MILWAUKIE DESIGN AND LANDMARKS COMMITTEE

- 5.1 Summary: Reliable Credit Parking Lot
Applicant/Owner: Tom Sisul, Sisul Engineering/L&B Holzman, LLC
Address: 10605 SE Main St
File: DR-14-07
Staff: Vera Kolias, Associate Planner

To: Design and Landmarks Committee
Through: Dennis Egner, Planning Director
From: Vera Kolias, Associate Planner
Date: November 25, 2014, for December 1, 2014, Public Meeting
Subject: File(s): DR-14-07
Applicant: L&B Holzman, LLC (represented by Tom Sisul, Sisul Engineering)
Address: 10605 SE Main St.
Legal Description (Map & Taxlot): 1S1E35AA 00300 and 00800
NDA: Historic Milwaukie

Landscape Plan

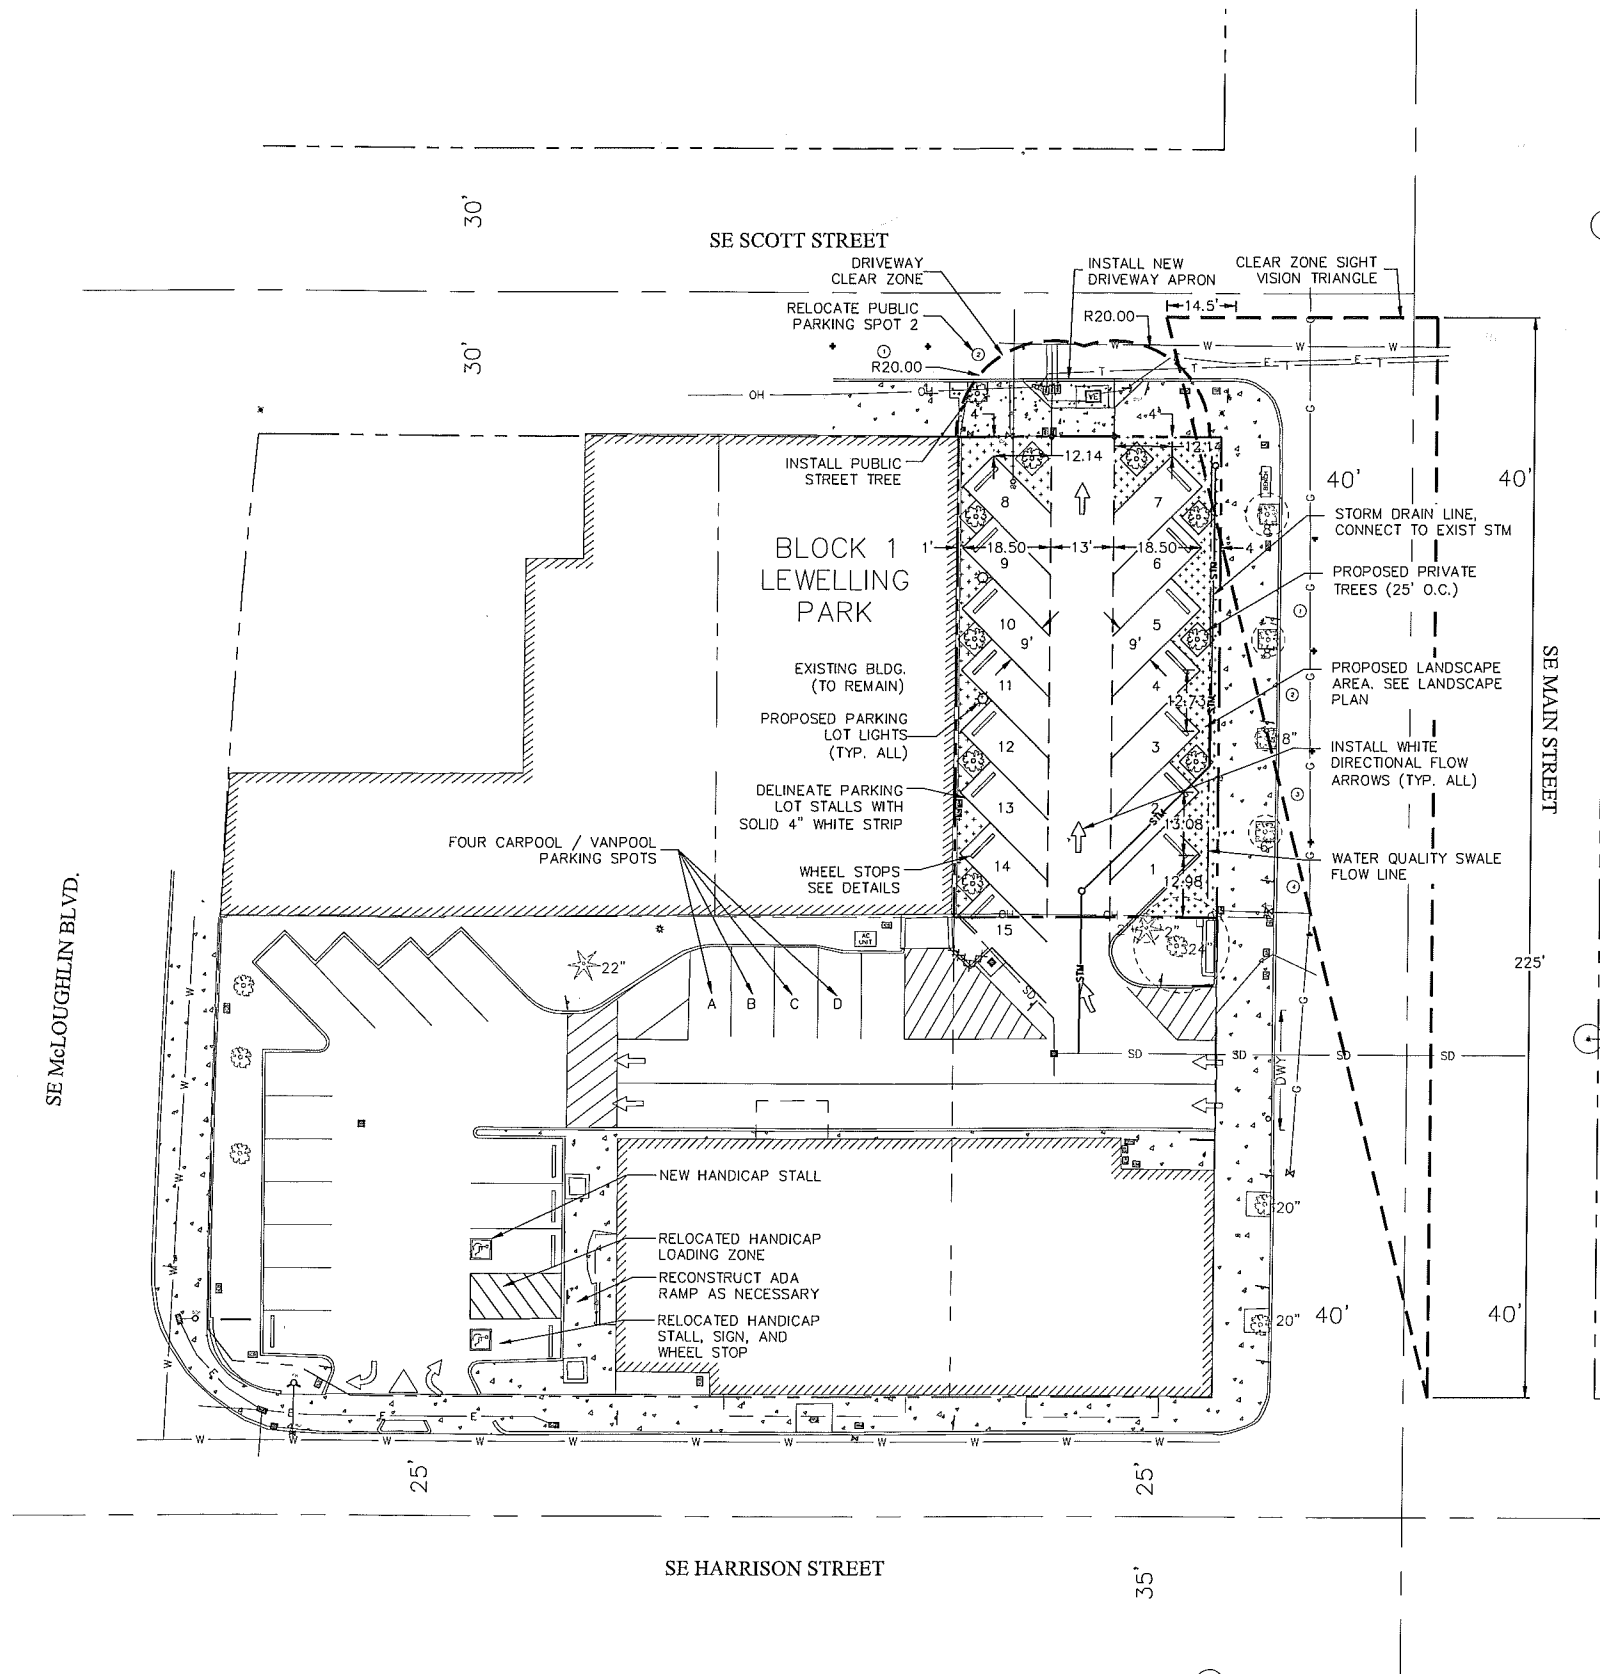
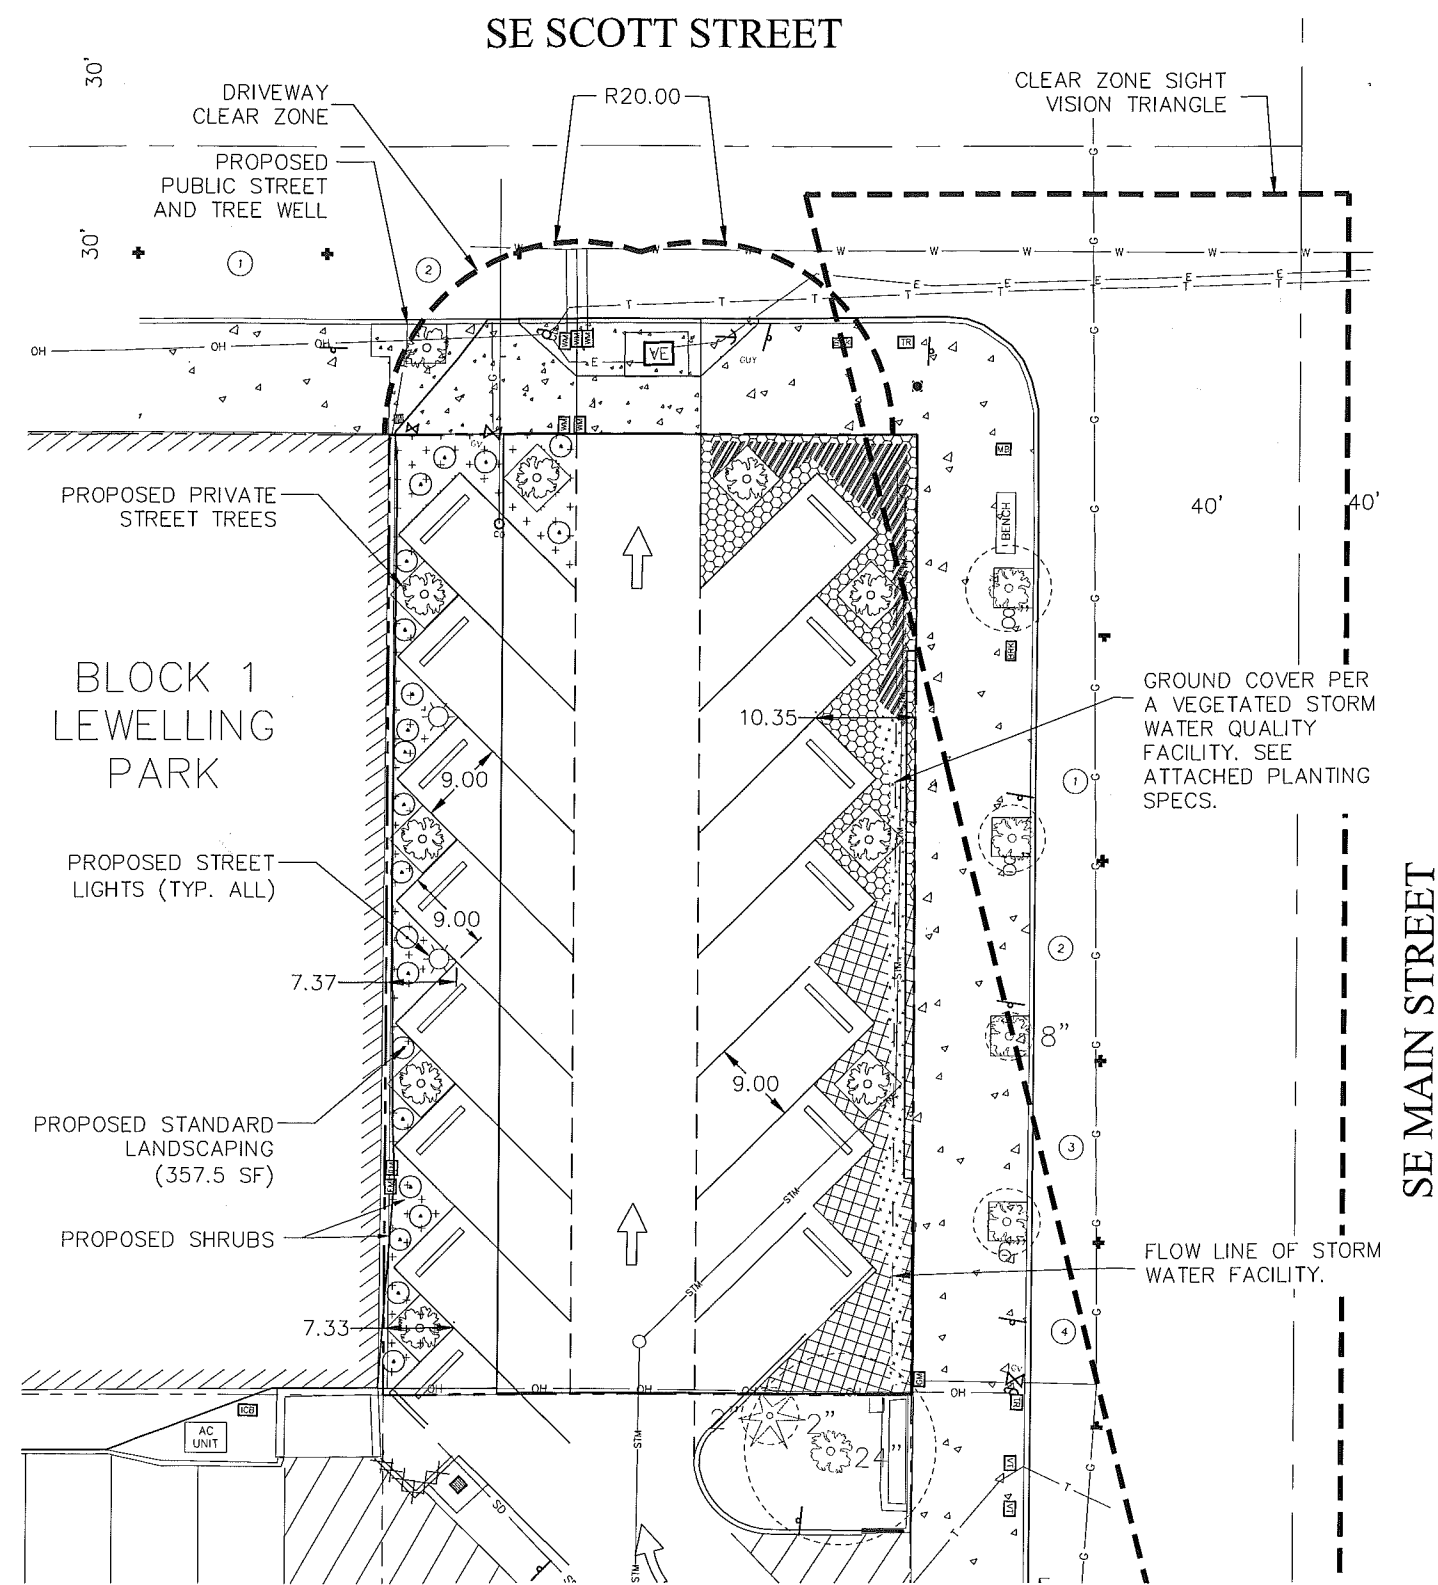
In order to create a sense of enclosure and define the edge between the sidewalk and the parking lot, as well as provide an area for stopping and viewing, alternative solutions include an architectural/structural wall that mimics a storefront to maintain an uninterrupted street edge, or a low stone or brick seat wall. These would provide screening and enclosure and separate pedestrians from the vehicles and maintain a public space (the sidewalk) distinct from the private space (the parking lot). See Figures 3, 4 and 5 for examples in the Portland area.

Staff recommends that the new lighting provided in the expanded portions of the parking area be an ornamental style, and that they be installed on the east side of the parking lot, within the planting area adjacent to the public sidewalk. The recommended wall must be designed to accommodate the siting of light fixtures and landscaping. These revisions would be consistent with the Downtown Design Guidelines.

- b. Parking lot fixtures shall be located within the perimeter landscaping area along the Main Street sidewalk.
 - c. A structural edge treatment such as an architectural/structural wall that mimics a storefront shall be installed. The wall must be designed to accommodate the siting of the parking lot light fixtures and landscaping. As an alternative, the DLC and Planning Commission may require a low stone or brick seat wall to provide this edge treatment. This is to separate pedestrians on the sidewalk from the parking lot and to define the pedestrian environment.

EasyLED 12" Area Light

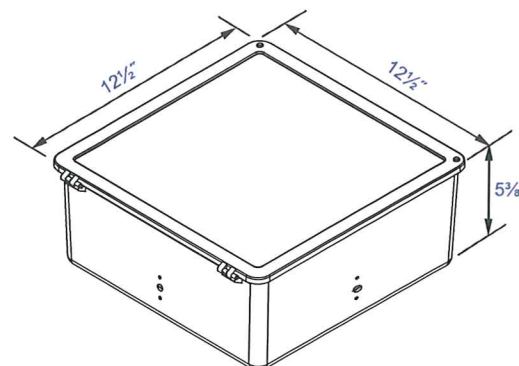
The existing parking area was developed in 1998, prior to the adoption of the Downtown Design Guidelines in 2003. The applicant has proposed to install new parking lot lighting in the same utilitarian style as the existing parking lot features. The existing lighting fixtures (see Figure 6) do not match the ornamental style prescribed in the Downtown Design Guidelines (see Figure 7) and are "not recommended."

The site is physically connected to the central downtown area, where other ornamental lights have been installed; specifically, across Main St from the site and further north as well. Maintaining consistency in light of no immediate plans to install light fixtures in this block is important. Although other downtown parking areas do not have this ornamental lighting, they were developed prior to the adoption of the Downtown Design Guidelines. The proposed site plan identifies two utilitarian light fixtures on the west side of the parking lot. Staff believes that installing ornamental lighting that is consistent with the Downtown Design Guidelines, on the street side of the parking lot rather than the west side, would be more attractive and would provide lighting for both employees using the parking lot and pedestrians on the adjacent sidewalk. Further, the Downtown Design Guidelines recommend that lighting should be located in landscaped areas wherever possible, and no lighting currently exists on that side of Main Street. The fixture location should be coordinated with the planned location of any future light fixtures installed if/when Public Area Requirements are built. Per MMC 19.606.3.F, the luminaries should have shielding for limiting light trespass.

- Parking lot fixtures shall be historic-style standards that are compatible with the downtown streetlight standards of the Public Works Standards.
- Parking lot fixtures shall be located within the perimeter landscaping area along the Main Street sidewalk.
- A structural edge treatment such as an architectural/structural wall that mimics a storefront shall be installed. The wall must be designed to accommodate the siting of the parking lot light fixtures and landscaping. As an alternative, the DLC and Planning Commission may require a low stone or brick seat wall to provide this edge treatment. This is to separate pedestrians on the sidewalk from the parking lot and to define the pedestrian environment.
